# Simplifying Seamless Redundancy

Norman Finn  
Cisco Systems

January 18, 2016

- **This document supports a ballot comment on P802.1CB D2.1.**
- At present, configuring P802.1CB requires a massive amount of configuration.
  - Every single Stream's identification (typically {VLAN, MAC address} pair must be configured on every port on which it might be received on every bridge in the network.
  - Every port on which each Stream might be output twice has to be configured with a sequence recovery function and its parameters (e.g. timeout value).
  - Every bridge through which the Stream passes should be configured with an Individual recovery function, requiring the configuration of Stream Identification and the IRF.
- This is a real problem – it will make bringing up a new Stream take too long to meet many needs. The volume of configuration information, itself, will be an impediment to adoption by users.

# Author's opinion

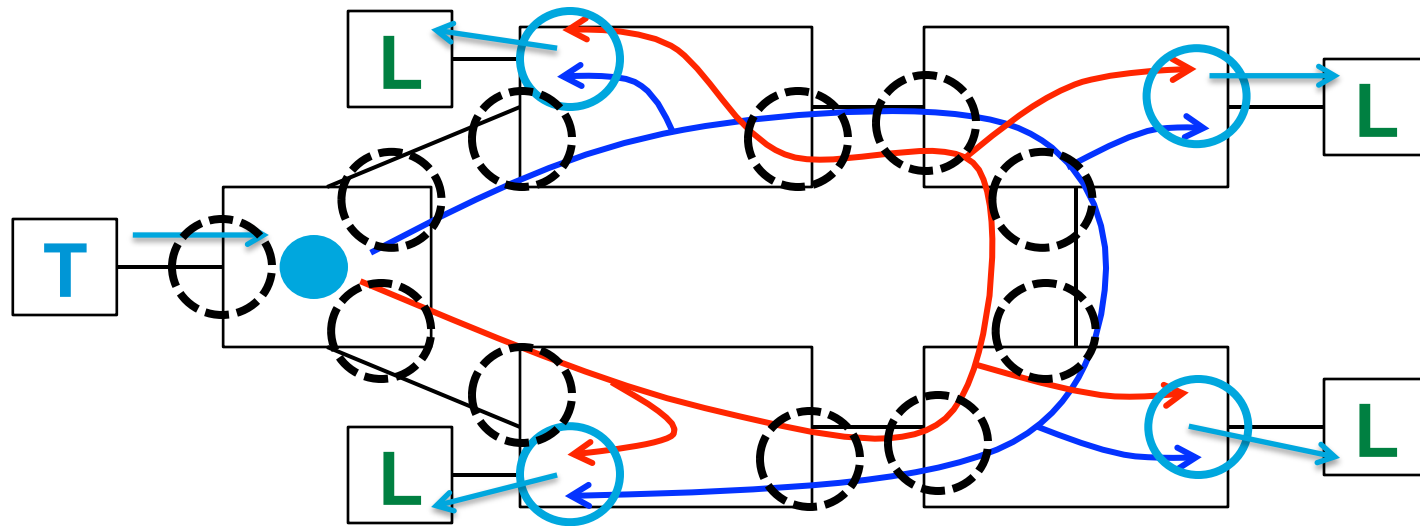
Sequence Recov. based on	Individual Recovery based on	Comments
1.	{VLAN, Dest}	{VLAN, Dest, Port}	<b>Non-starter.</b> Identical packets are criss-crossing through the network.
2.	{VLAN, Dest}	{VLAN, Dest, A/B tag}	<b>Non-starter.</b> Almost-identical packets are criss-crossing through the network. (The A/B bits in the tag are not used by forwarding.)
3.	{Dest}	{VLAN, Dest}	→ <b>contender.</b> SR cannot be used except on multicast streams, and multicast DAs are required (now) only for bandwidth reservation.
4.	{Source, VLAN}	{Source, VLAN, Dest}	No. Requires multicast DAs without gaining advantages of per-Stream sequencing.
5.	{Source, VLAN}	{Source, VLAN, A/B tag}	→ <b>Compatible with HSR/PRP. Seamless Redundancy not locked to MSRP.</b>

# Which ports are sequence filtered?

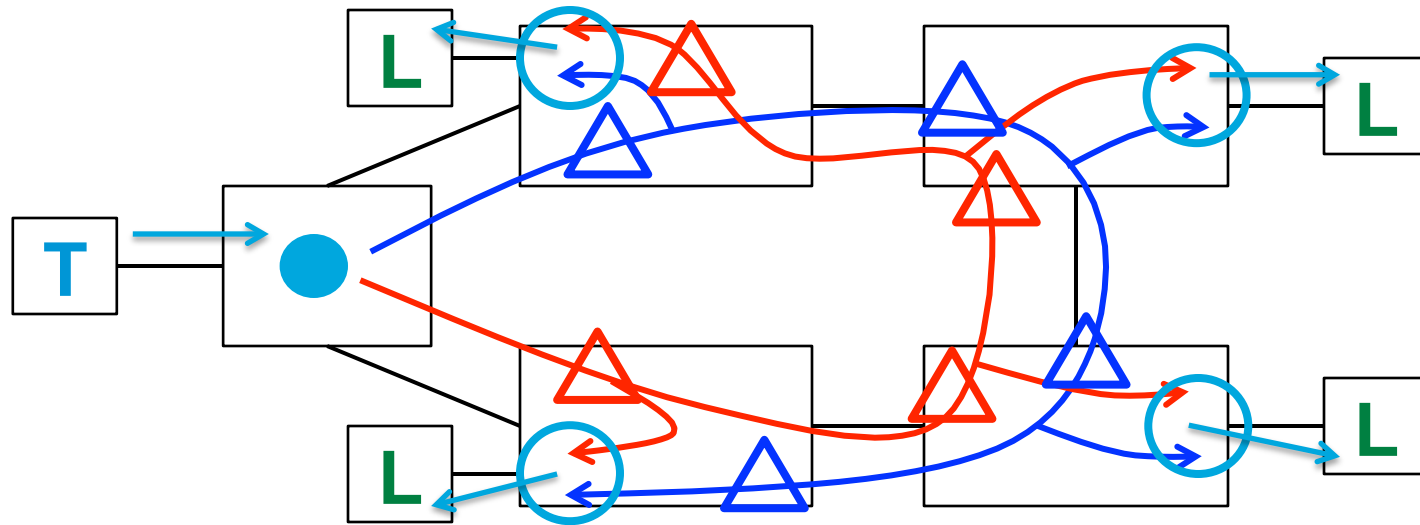
- **You can auto-configure Sequence Recovery on every port!**
- The dotted circles are functional, but never discard a packet, because the two streams **do not both egress** on those ports.

- You can auto-configure an Individual Recovery function in every forwarding function, separate from any particular port.
- IF identical packets entering different ports are the same Stream.

# Sequence Recovery on every port $\neq$ Sequence Recovery in Relay Function

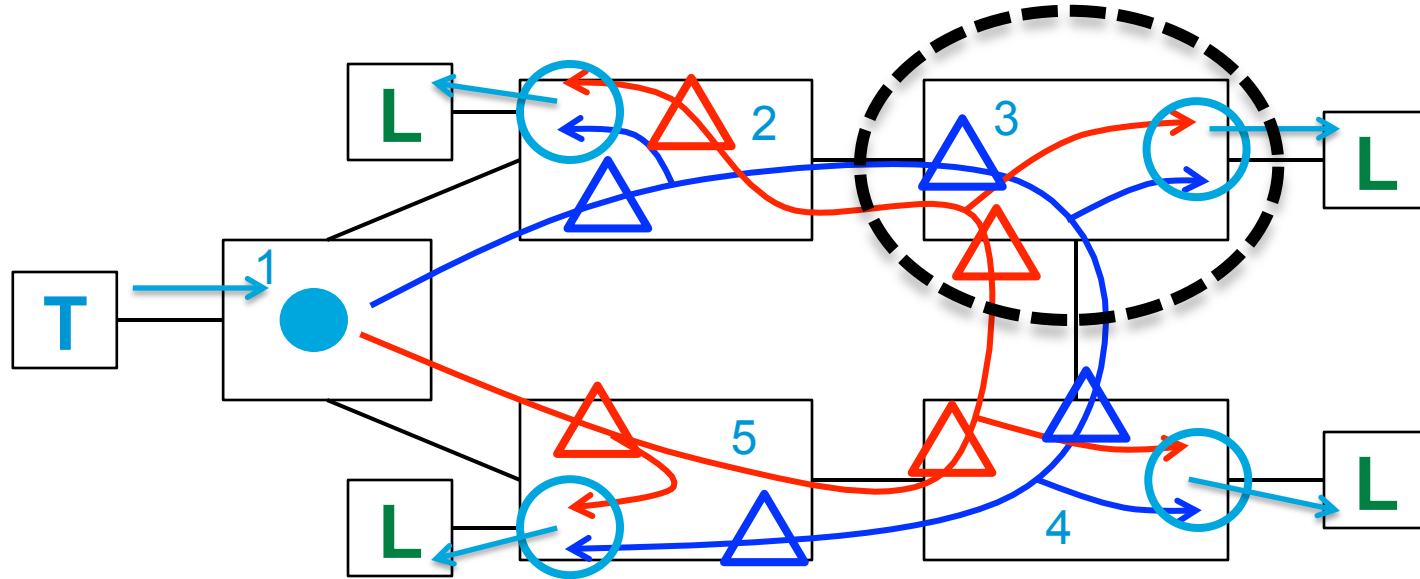
- We do want to filter packets going to the Listener.
- We do not want to filter packets on the ring – that can lead to latent errors.

- In the previous slide, in bridge 3, you
  - **Do** want to discard duplicates sent to the Listener.
  - **Do not** want to discard duplicates on the ports to Bridges 2 and 4.
- A single Sequence Recovery function in the bridge 3 relay function that does not pay attention to individual ports **could**:
  1. Receive red packet #10 from bridge 4, and relay it to L and bridge 2.
  2. Receive blue packet #10 from bridge 2, discard it as a duplicate, and not send it either to L or to bridge 4.
- In one sense, this is no problem, because we know that bridge 4 has already received packet #10. It also makes more bandwidth available for best-effort traffic.
- But, if link 1—5 fails, we don't know for sure that packet #11 will reach bridge 5; there may be a “**latent error**”, e.g. a misconfiguration that blocks blue packets on link 4—5.
